3800 ISLAND WAY– BOAT DOCK REPLACEMENT

SP- 2021-0021D

Project Name &
Case Number: **3800 ISLAND WAY Boat Dock Replacement SP- 2021-0021D**

Variance Request: **LDC 25-8-281(C)(2)(b) - To allow construction within 150 feet of a Rimrock Critical Environmental Features (CEF)**

3800 ISLAND WAY
PROPOSED CONDITIONS SITE PLAN

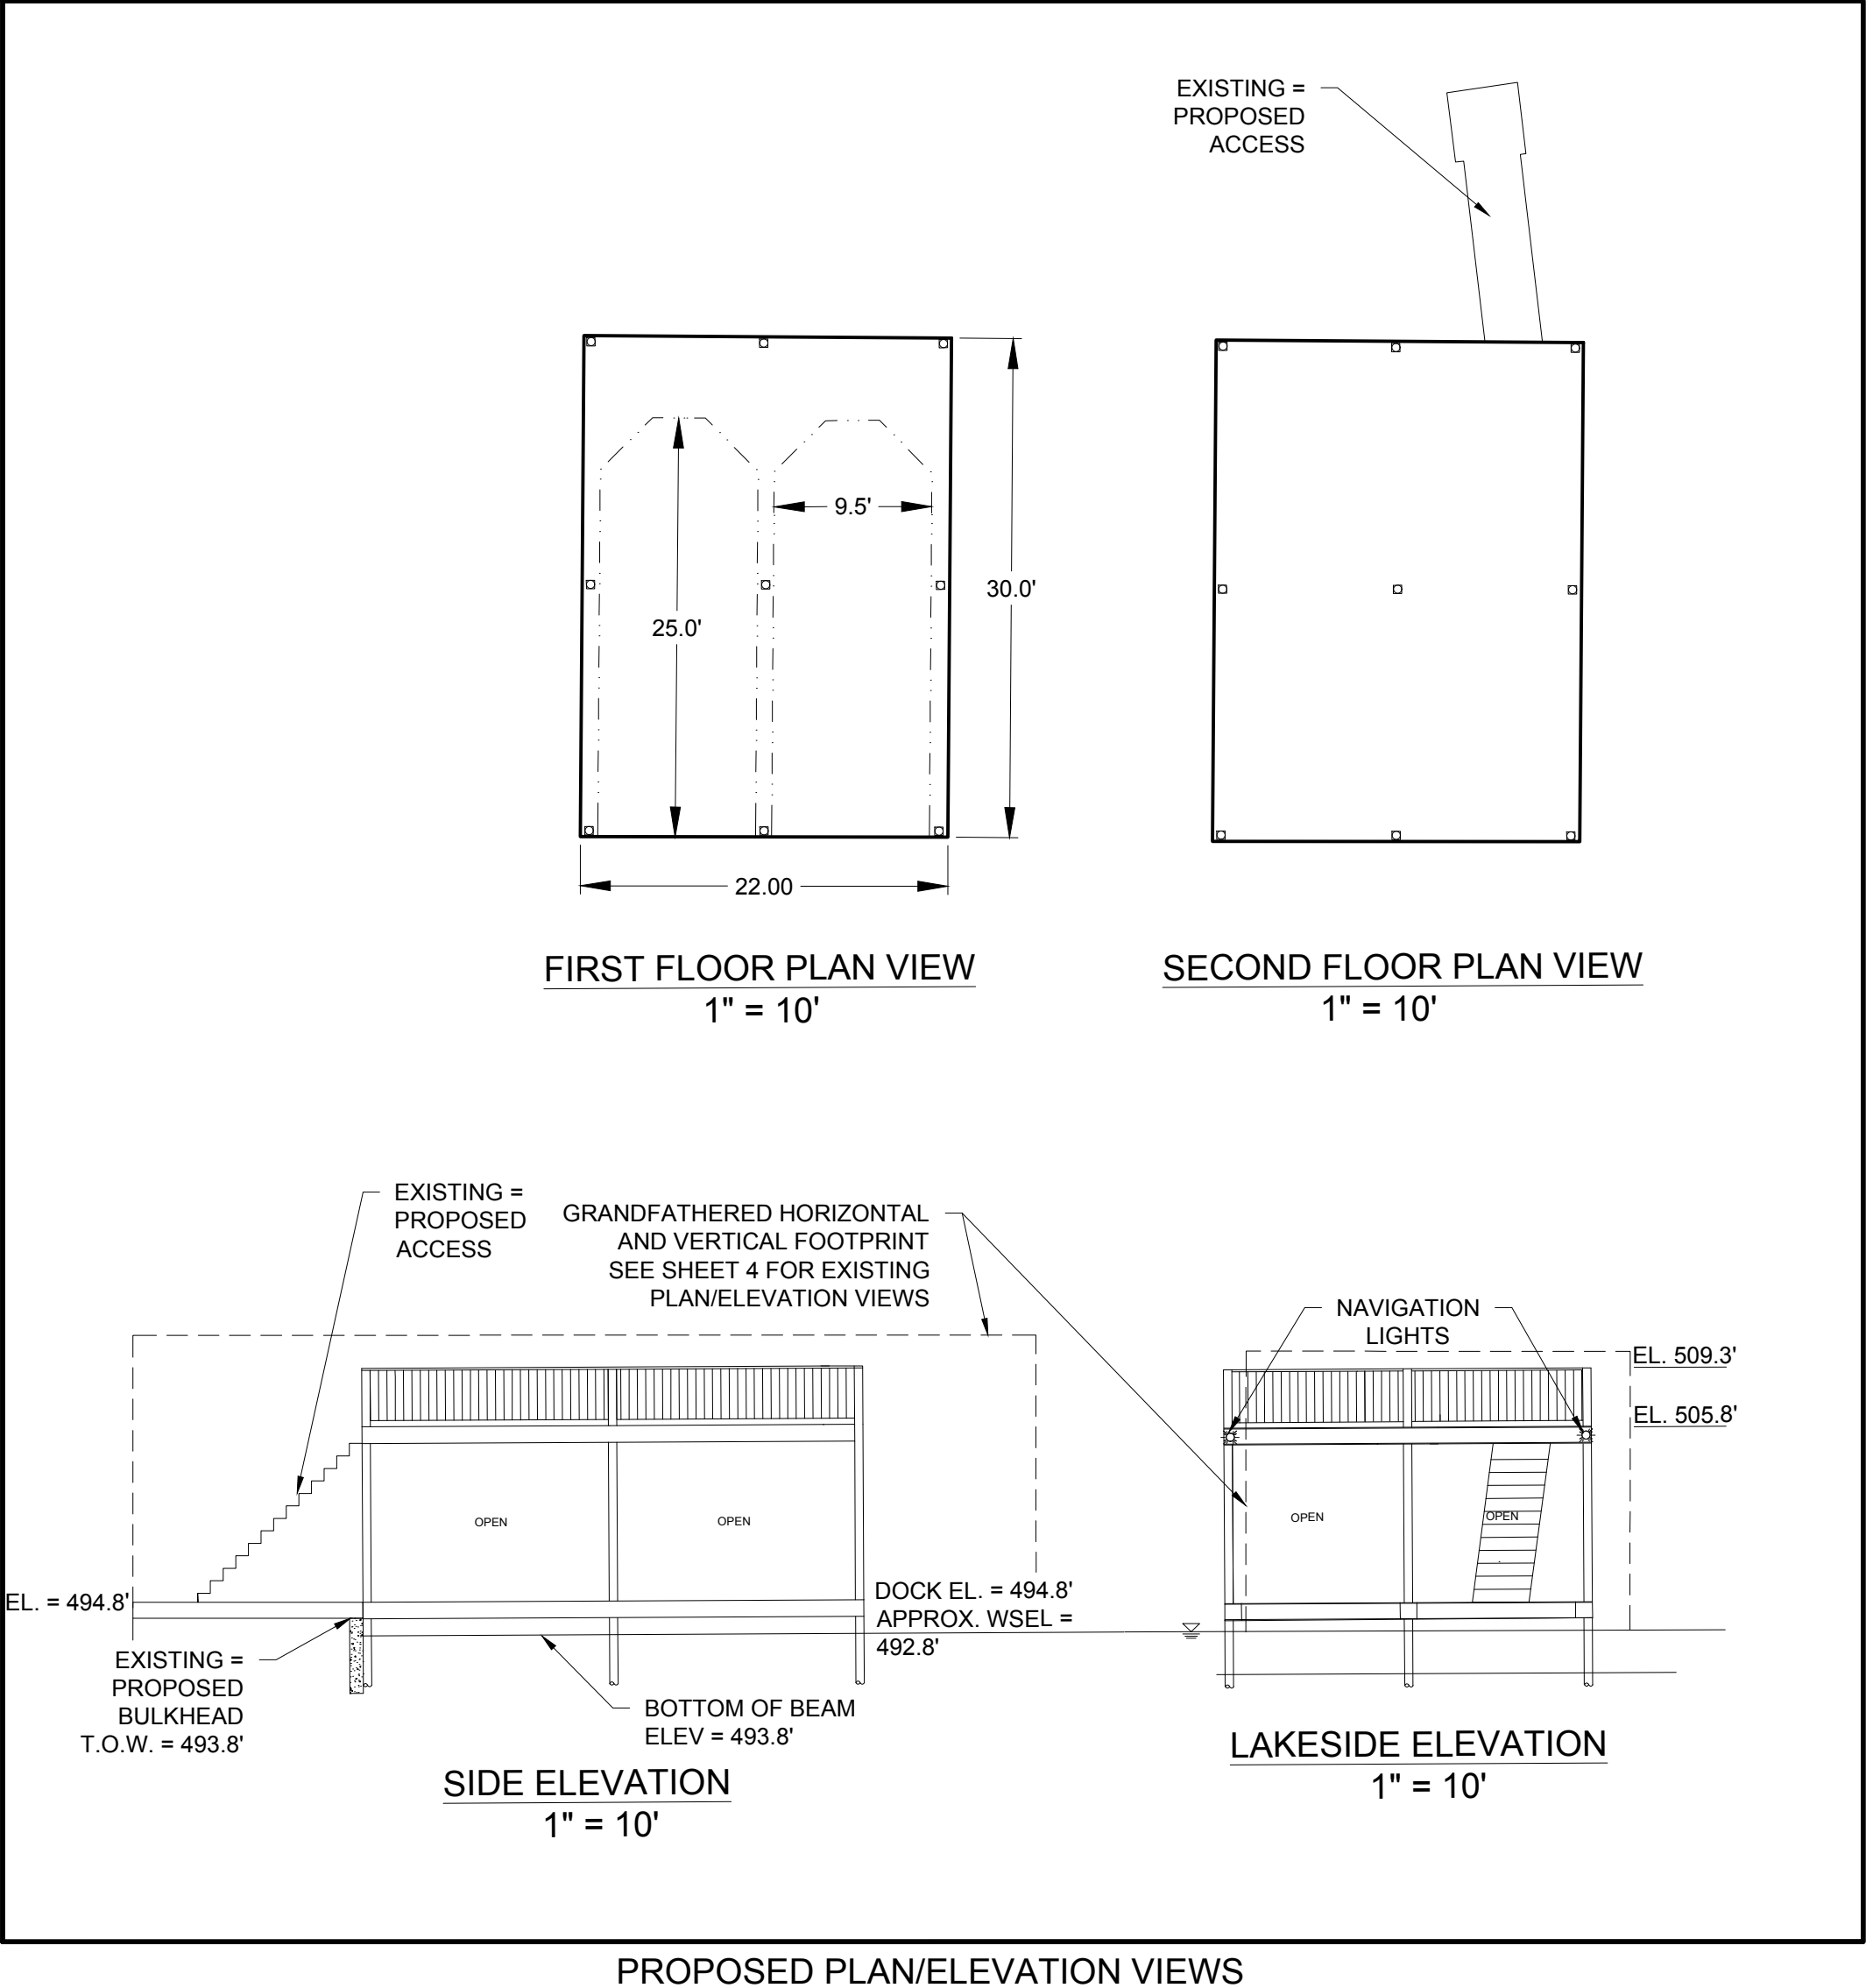
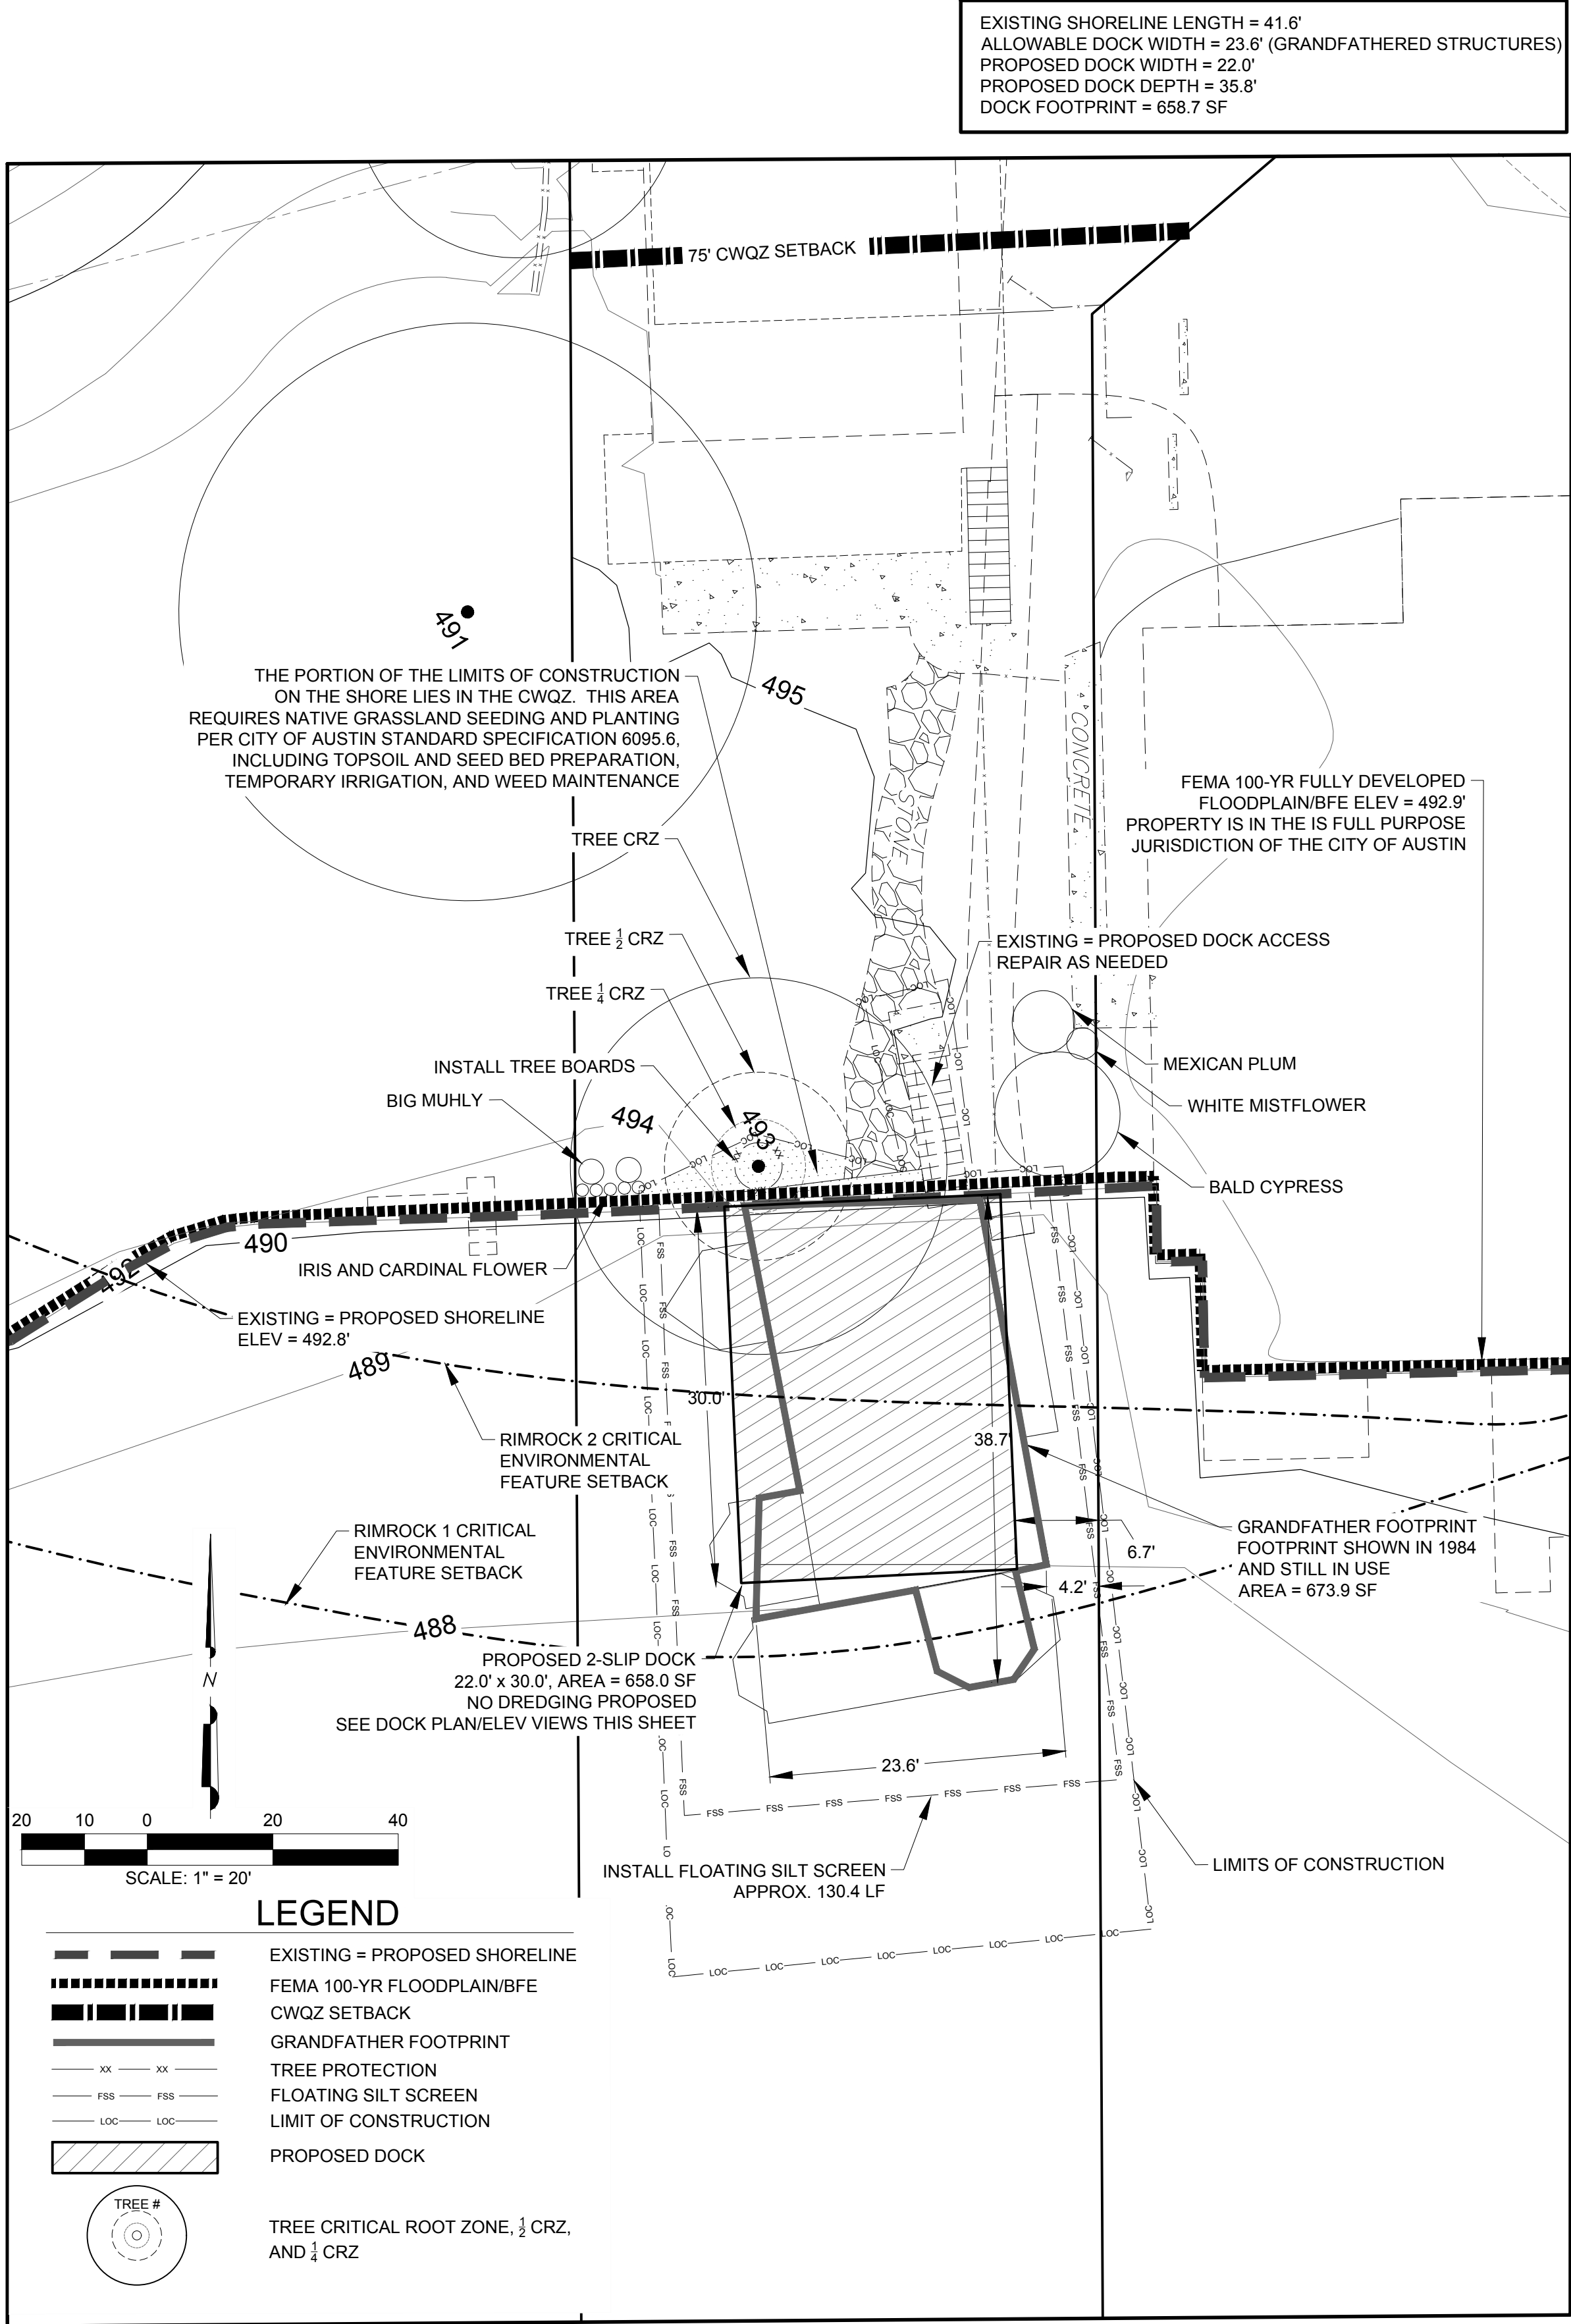
Yes. No disturbance of the rimrock CEF is proposed, all proposed construction activities are to occur downgradient of the rimrock CEFs, and construction is to occur from the lakeside by barge. The proposed construction to be performed from a barge provides greater overall environmental protection. Additionally, the applicant is providing wetland plantings that will reduce shoreline erosion and sediment-laden surface runoff from discharging into the lake.

Staff Recommendation: Staff recommends the variance as the Findings of Fact have been met, with the staff recommended condition that all construction be completed by barge.

1. That the construction be completed by barge.
